SERVICE ALERT

16-TSB15

GM 2007+ TOYOTA TUNDRA 2007+ LIGHT ADAPTER 16071160

UPDATE 10/21/08

CORRECT WIRE CONFIGURATION

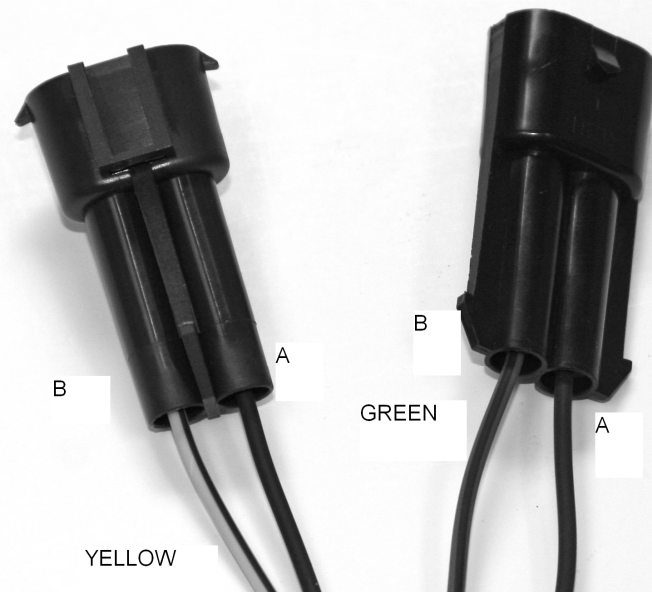
IT has been determined that most 16071160 light adapters shipped prior to 09/12/08 have a wiring error that will result in malfunctioning plow lights.

Customer may contact BPC for replacement adapters, or the problem may be corrected by the installer by swapping the wires at the LONG connectors on the 16071160 harness. This will MATCH THE TRUCK LIGHT HARNESS color scheme.

TERMINAL REMOVAL

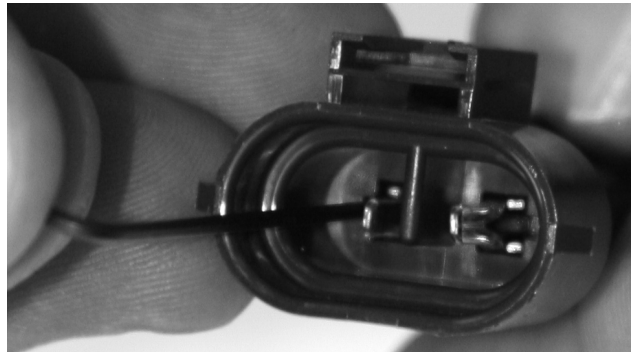
Removing the terminals for both long connectors can be done easily with a stiff pick or pin. In the pictures below a small hex key was used. Paper clips are too flexible.

On the connector with the green wire, the pick should be inserted on the inside face of the terminal. You are pushing back a small metal retaining piece, which will allow the terminal to be removed.

On the connector with the yellow wire, the pick should be inserted on the outside face of the terminal.

Reinsert the terminals as shown on the first page. The wire colors should now match the truck lighting harness (GM). If they do not, recheck the adapter.
